Re: Lisbon Facility
License SUA-1119, Docket No. 40-8084
Tailings Technical Evaluation

Enclosed pursuant to license condition #44 (E), is the annual technical evaluation for Lisbon's upper and lower tailings impoundment and the Bisco Lake embankment. The findings indicate continued stability and safety of the impoundments.

Subject: Bisco Lake Dam Inspection
Upper Tailings Dam Inspection
Lower Tailings Dam Inspection

PAGE 5/13

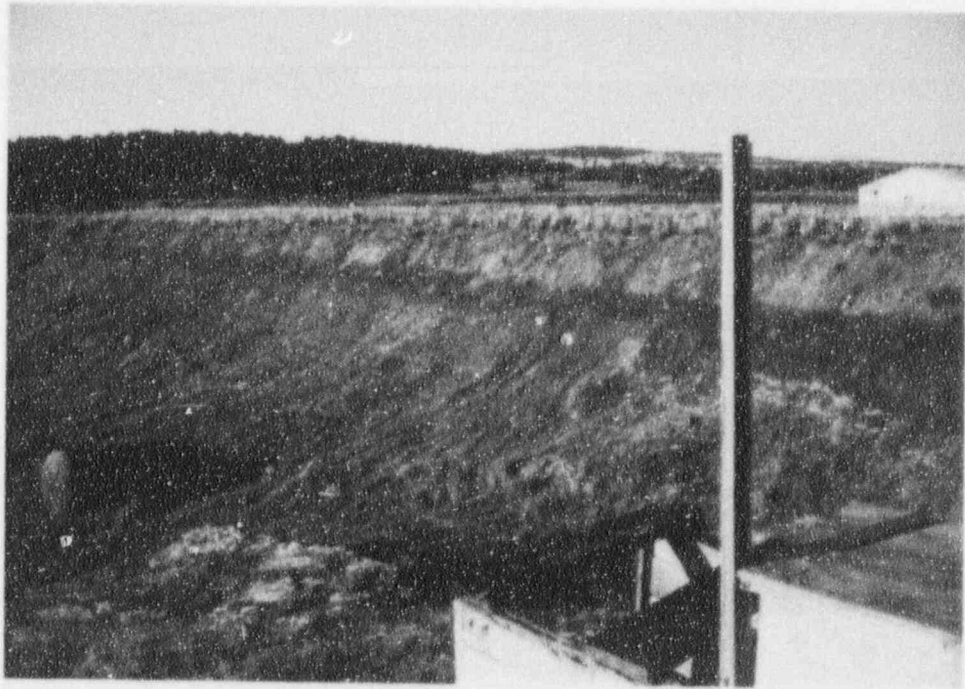
Comments and Photographs: SEE PAGE 5/13 FOR PHOTO LOCATIONS

Comments and Photographs: SEE PG. 5/13 FOR PHOTO LOCATIONS

Comments and Photographs: SEE PG. 5/13 FOR PHOTO LOCATIONS.
IF THE WATER DEPTH IN THE BASIN APPROACHES APPROXIMATELY
5', REGULATIONS REQUIRE THAT MORE FREQUENT
MONITORING BE ACCOMPLISHED.

PHOTO LOCATIONS
DAM INSPECTION
UPPER TAILINGS
RIO ALGOM
1" = 500'
5-2-94

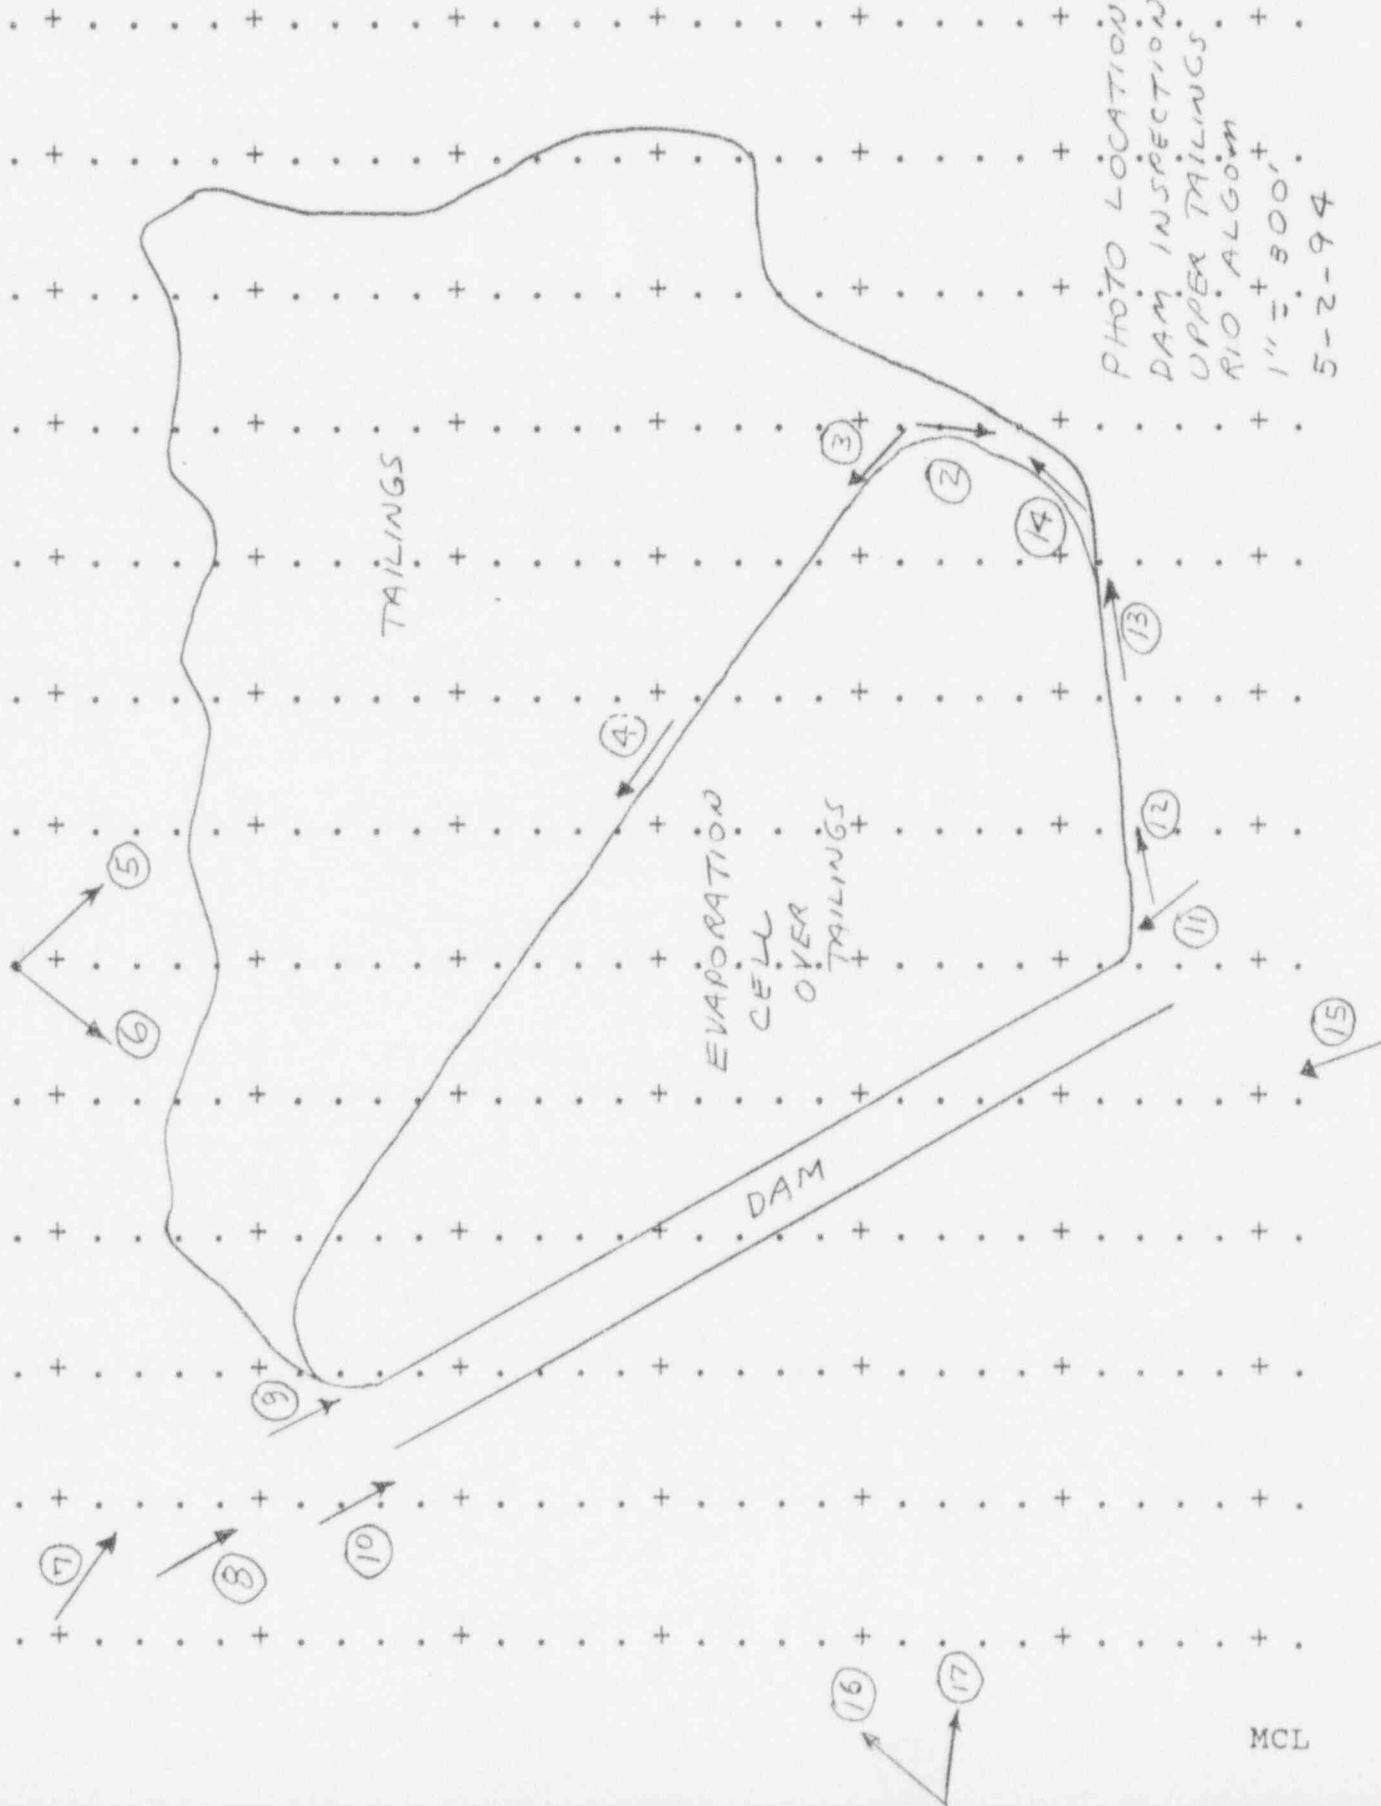
Comments and Photographs: SEE PAGE 5/14 FOR PHOTO LOCATIONS.

* WAVE EROSION HAS OCCURRED ON THE INSIDE FACE OF THE EVAPORATION CELL BERM. RIO ALGOM IS PRESENTLY WIDENING THE BERM ON THE OUTSIDE, AND IT IS MY UNDERSTANDING THAT RIO ALGOM PLANS TO REPAIR THE ERODED AREA. IN MY OPINION, THIS EROSION HAS NOT YET PROGRESSED TO A POINT WHERE THE BERM IS STRUCTURALLY UNSTABLE.

SEEPAGE	location	gpm	sediment	comments
	1	[]	[]	SLIGHT SEEPAGE INTO THE EVAPORATION CELL
	2	[]	[]	DIKE WHERE WAVE EROSION HAS OCCURRED,
	3	[]	[]	
	4	[]	[]

1. VERY MINOR SURFACE EROSION HAS OCCURRED ON THE OUTSIDE LOWER FACE OF THE DAM WHERE THE VEGETATION IS NOT YET ESTABLISHED. IN MY OPINION, THIS CREATES NO L OVE RISK TO STABILITY

2. WAVE EROSION HAS OCCURRED ON THE INSIDE FACE OF THE EVAPORATION CELL BERM. RIO ALGOM IS PRESENTLY WIDENING THE BERM ON THE OUTSIDE, AND IT IS MY UNDERSTANDING THAT RIO ALGOM PLANS TO REPAIR THE ERODED AREA. IN MY OPINION, THE EROSION HAS NOT YET PROGRESSED TO A POINT WHERE THE BERM IS STRUCTURALLY UNSTABLE.

SKETCH - Indicate North, downstream, seeps, leaks, sinkholes etc.

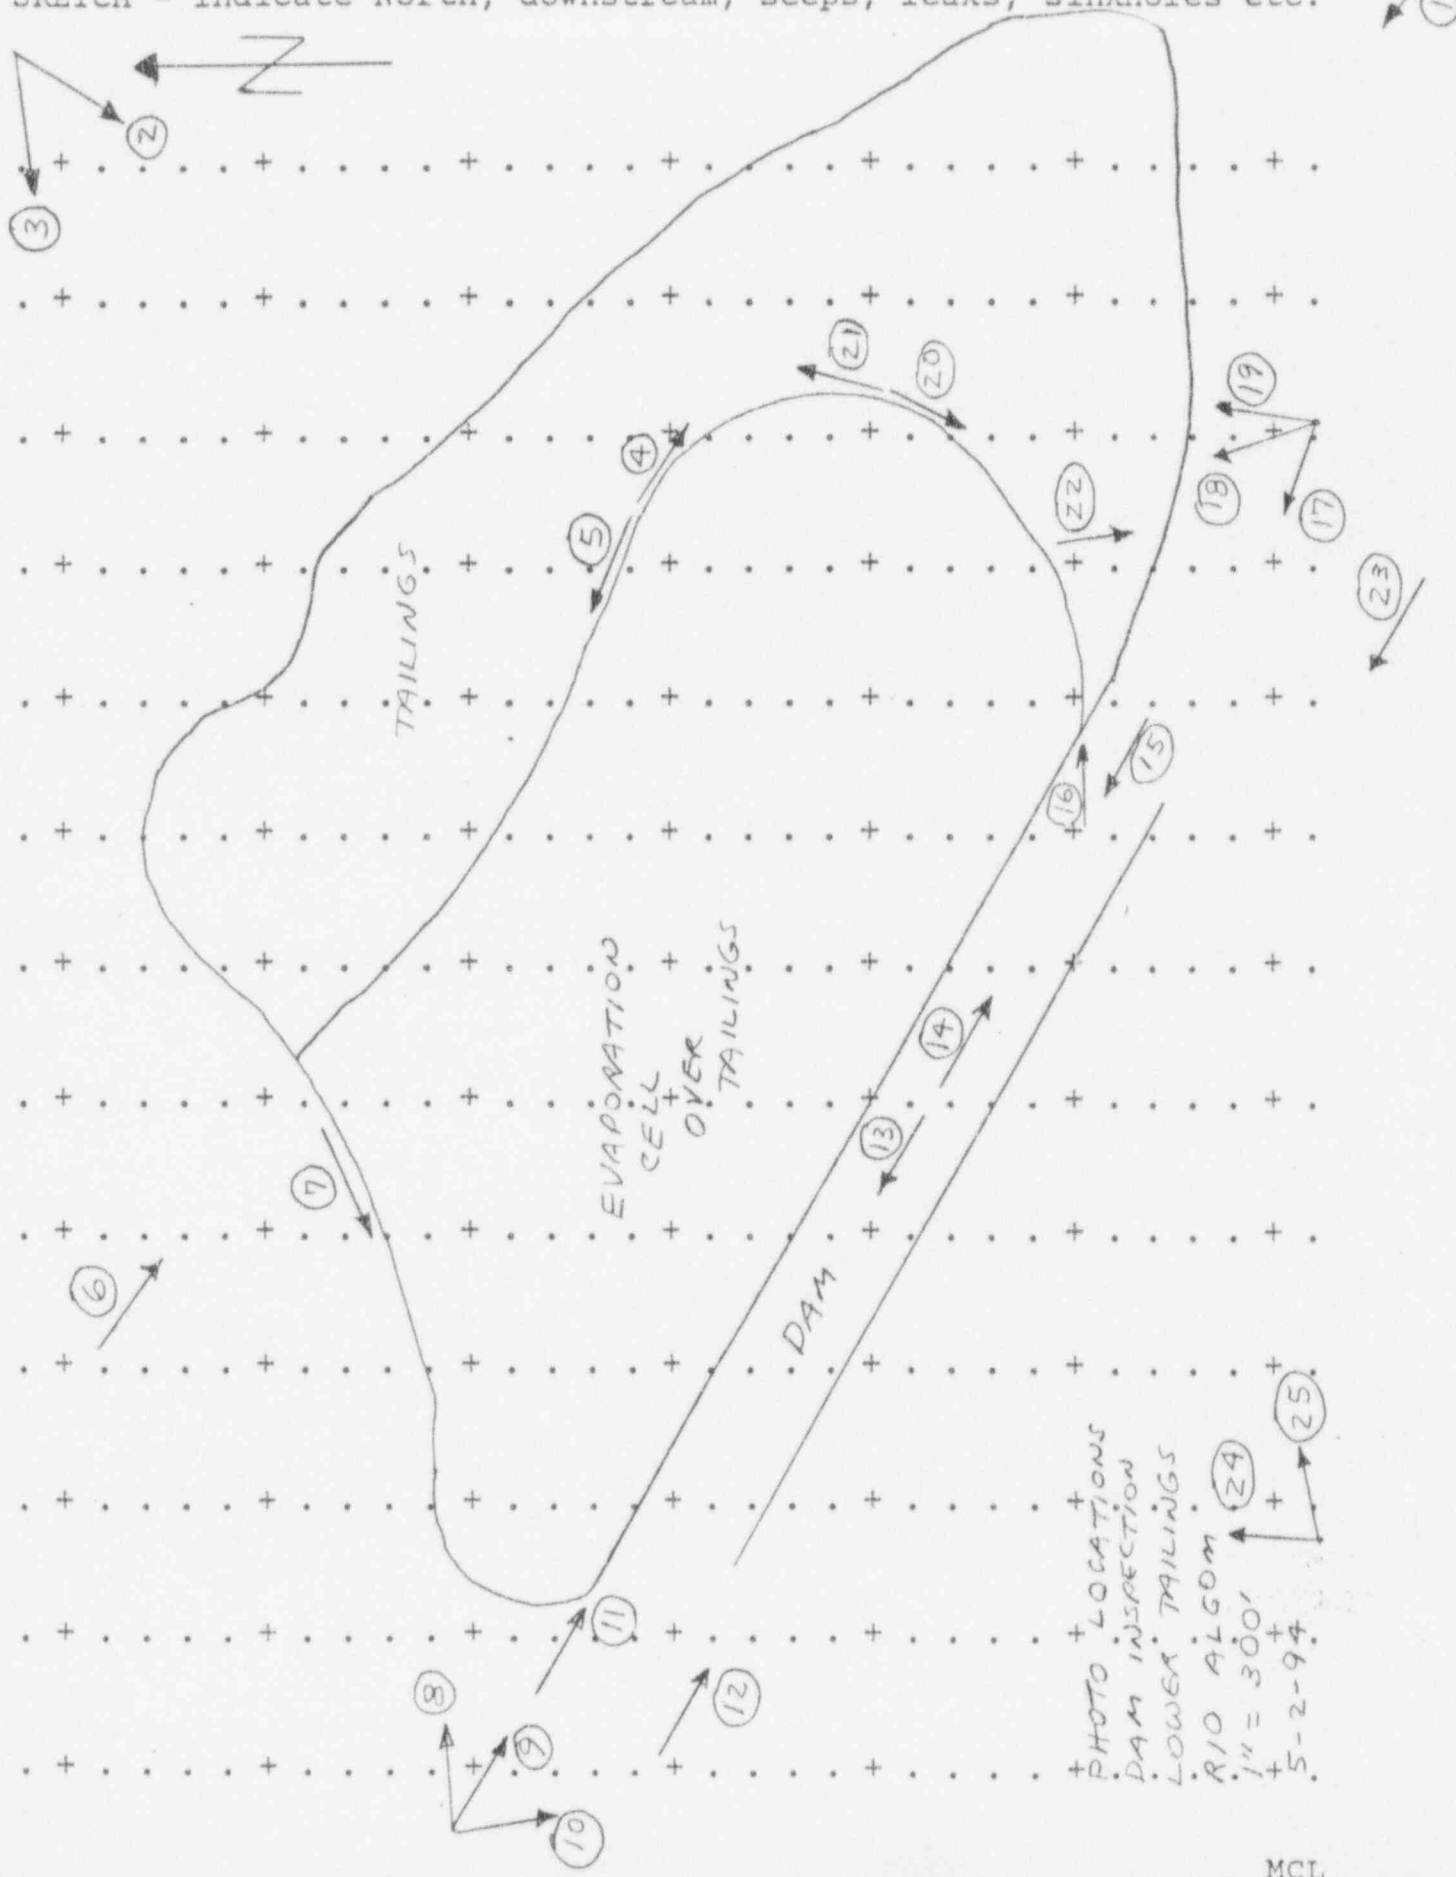
Comments and Photographs: SEE PAGE 5/18 FOR PHOTO LOCATIONS.

* WAVE EROSION HAS OCCURRED ON THE INSIDE FACE OF THE NEW EVAPORATION CELL (BUILT DURING THE SUMMER OF 1993) BERM, IT IS MY UNDERSTANDING THAT RIO ALGOM PLANS TO REPAIR THE ERODED AREA. IN MY OPINION, THIS EROSION HAS NOT PROGRESSED TO A POINT WHERE THE BERM IS STRUCTURALLY UNSTABLE.

1. VERY MINOR SURFACE EROSION HAS OCCURRED ON THE DAM WHERE VEGETATION HAS NOT YET BEEN ESTABLISHED, BUT THIS POSES NO RISK TO STABILITY
2. DURING THE SUMMER OF 1993, AN EVAPORATION CELL WAS BUILT OVER PART OF THE LOWER TAILINGS ON TOP OF THE SOIL CAP COVERING THE TAILINGS. OBSERVATION OF THIS EVAPORATION CELL AND BERMS, AND REVIEW OF THE 11-15-93 CONSTRUCTION REPORT SUBMITTED BY RIO ALGOM TO THE U.S. NUCLEAR REGULATORY COMMISSION INDICATES THIS EVAPORATION CELL CONSTRUCTION MEETS STANDARDS. SOME WAVE EROSION HAS OCCURRED ON THE INSIDE FACE OF THE BERM. IT IS MY UNDERSTANDING THAT RIO ALGOM PLANS TO REPAIR THIS ERODED AREA. IN MY OPINION, THIS EROSION HAS NOT PROGRESSED TO A POINT WHERE THE BERM IS STRUCTURALLY UNSTABLE.

3. DURING THE SUMMER OF 1993, A PORTION OF THE OUTSLOPE ON THE LOWER TAILINGS DAM WAS MODIFIED FROM A 3H:1V SLOPE TO A 5H:1V SLOPE. IT IS MY UNDERSTANDING THAT THE QUALITY OF CONSTRUCTION, MATERIALS USED, AND TESTING ACCOMPLISHED, WAS SIMILAR TO THAT USED WHILE BUILDING THE EVAPORATION CELL OVER PART OF THE LOWER TAILINGS.
